Area Walk-By Checklists (AWCs)

Table D-1. Summary of Area Walk-By Checklists

Area Walk-By Checklist (AWC)

MG_4173

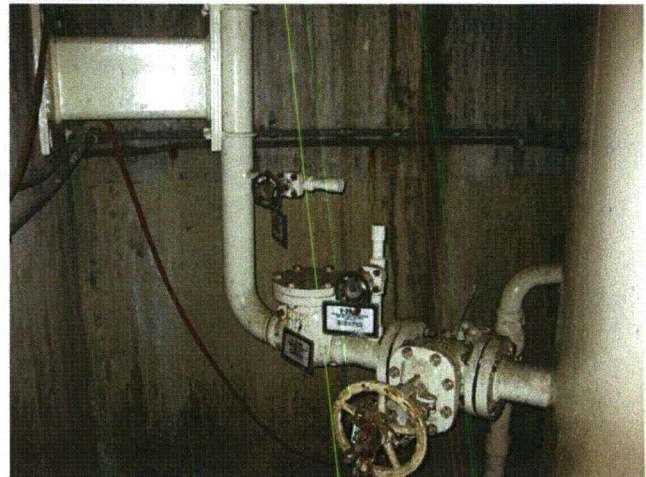
Wooden ladder is not tied at the Top, tracked by IR 1405874. Operations was notified and resolved.

MG_0698

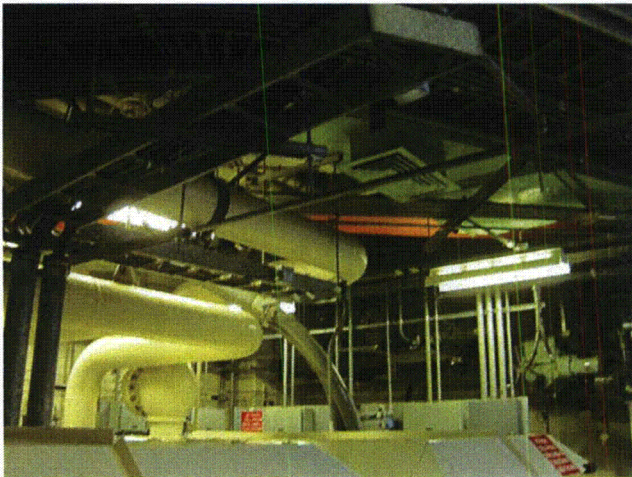
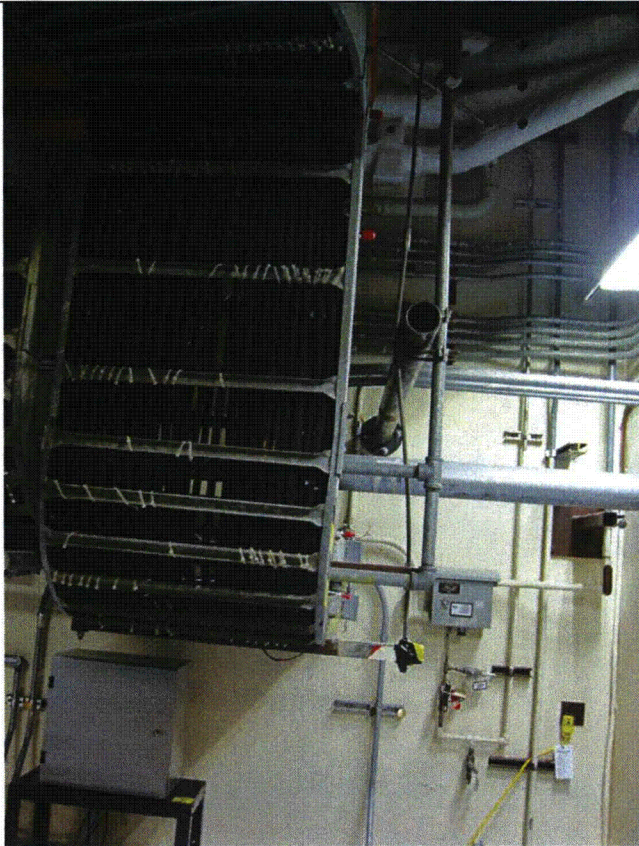
Cable Tray hanger Rod for Tray 10, 11 & 12 is not consistent with GIP (warped). Deluge piping is not seismically installed, however, it is consistent with NFPA-13 and is acceptable. Being tracked by IR 01402715 - Bent hanger rod by RB 51' airlock.

MG_0969

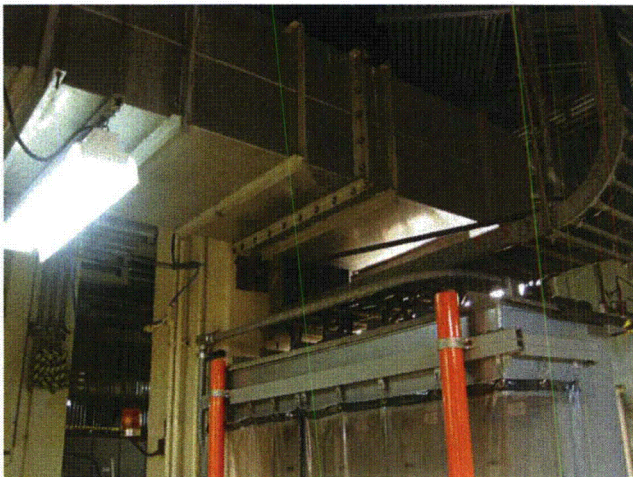
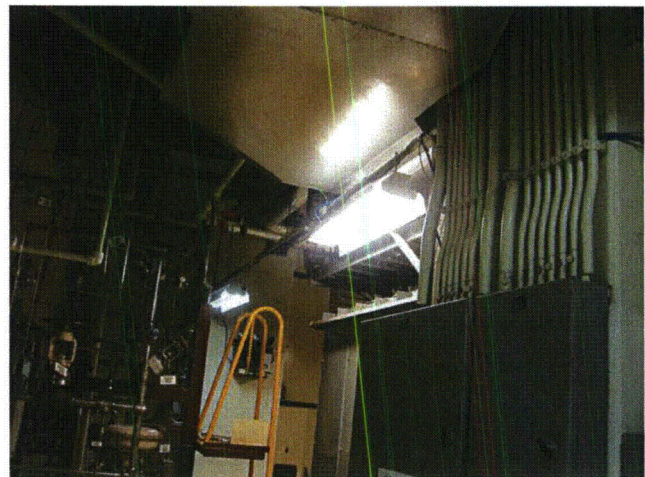
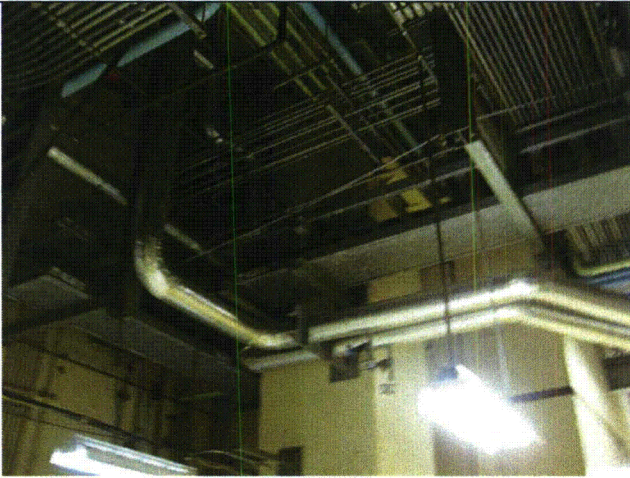
Overhead light in front of 1A21B-4160V has an open S Hook, tracked by IR 1403305. Light is far enough away from any equipment not to be a seismic interaction issue, but is a personnel safety issue.

MG_0936

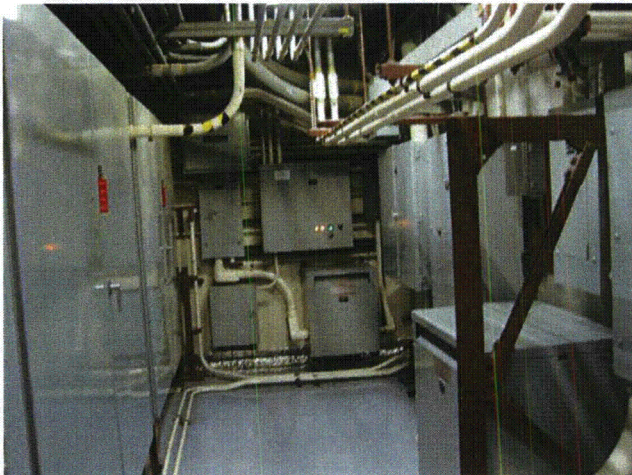
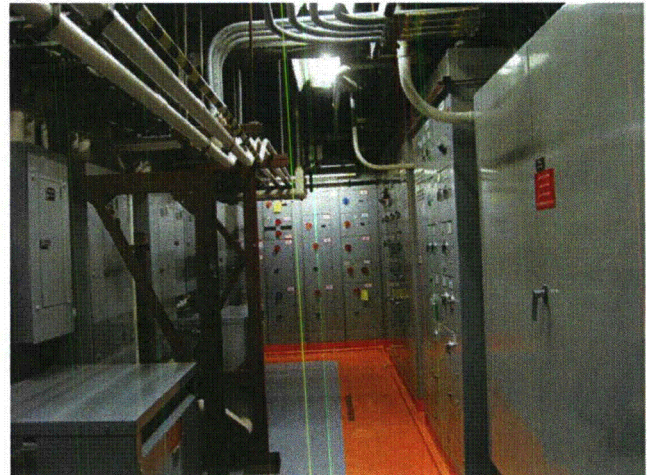
One bend conduit support rod above Disconnect Panel B-2. However, adjacent support rods are within 3 feet, which is close enough to preclude failure of the conduit if the rod fails. This is tracked by IR 1403359.

MG_0768

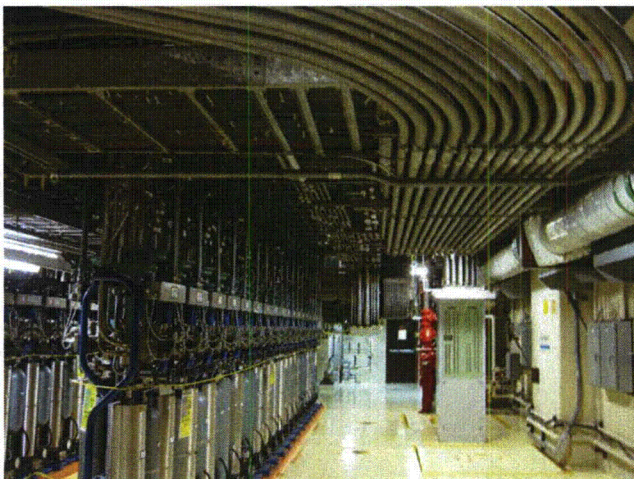
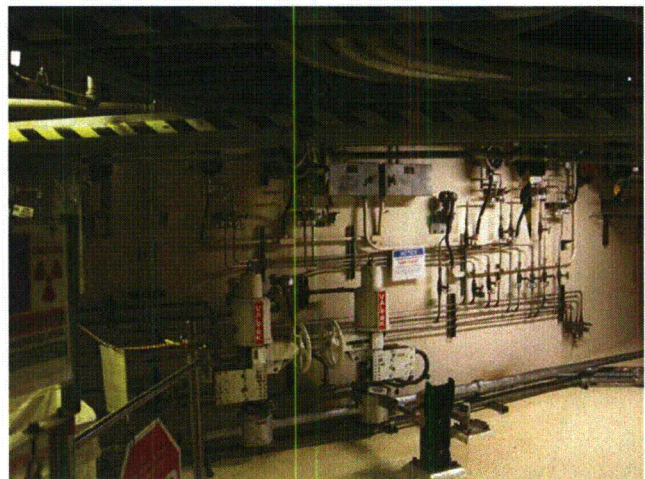
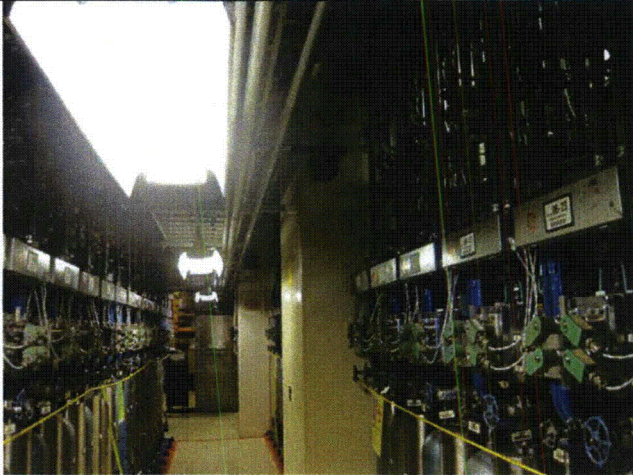
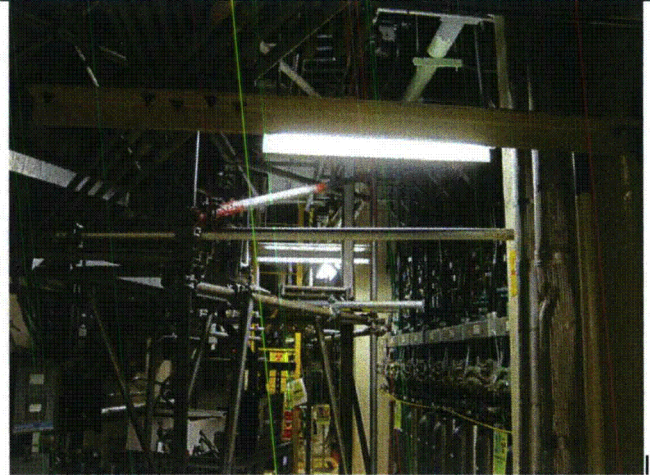
Surface Oxidation on Bolts at the Base Plates. The degraded bolts had previously been identified in 2000. Gusset plates were added to the Heat Exchanger base to make up for the deficient bolts. The gusset plate modifications are detailed in Calculation C-1302-241-E310-107 Rev 0
